DB15 CONNECTOR MOUNTED ON FP OF MODULE.
CONNECTED TO IDC 16 CONNECTOR MOUNTED ON BOARD VIA MASS TERMINATION CABLE.

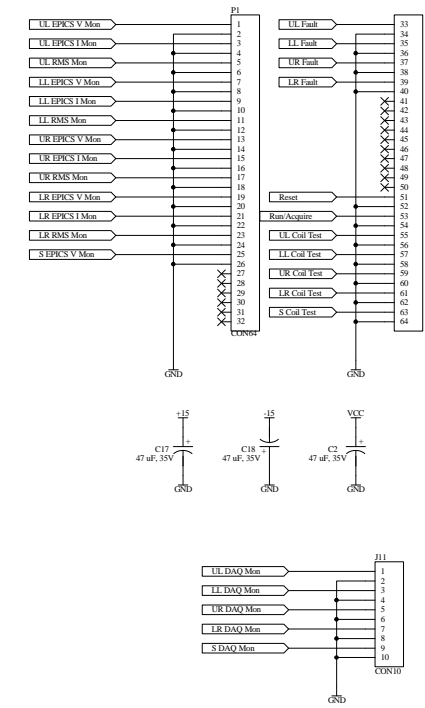
Rev	Description	Date
A	Initial Release	10/00
B	1. Changed connection of K5 to correct polarity for coil (Pins 1&6 reversed) 2. PCB traces rerouted for K5 and C64. 3. Hole sizes for PAR5s increased to allow sockets. 4. J12 rotated on PCB.	6/01
B1	Swapped pins 10 and 12 on relays K1, K2, K3, K4 and K5 to invert enable signal. Change was done by removing relays from board and adding an interface socket to make the switch.	10/01
B2	1. Changed C47, C45, C74, C72 to 47pF. 2. Changed RSS, RK3, R137, R129 to 110 ohms. (Better compensation of PAR5s)	1/02
B3	Rev B3 revision notes: Rev B3 typically applies to BS, RM, ITMs and ETMs 1. 7.2K feedback resistor is changed to 21.6K ohms (3 ea. 7.2K in series) 2. 1Kohm in series with 5uF is changed to 100K in series with 5uF for BS, RM and ETMs. Remains at 1K for ITMs. 3. 7.2K in series with coil output is changed to 3 ea. 1K in series. 4. 10 ohm current limit resistors on PAR5 changed to make a 1-ohm current limit resistor. 5. DAQ coil output Monitors changed to have 0.05uF capacitor and 10K resistor, making a 300Hz HPF.	9/02
